SUTPHEN CORPORATION SALES TECHNICAL BULLETIN

COMMAND CONSOLE VENTS

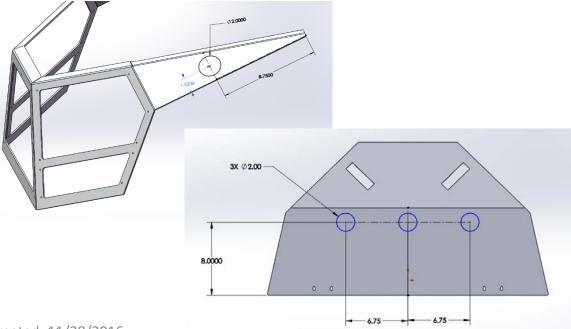
In order to reduce the build-up of excessive heat inside the lower command console on the Sutphen custom chassis, five (5) vents will be added. There will be three (3) vents in the lift-up lid and one (1) each side on the triangular portions. You will begin to see these on production units going forward.
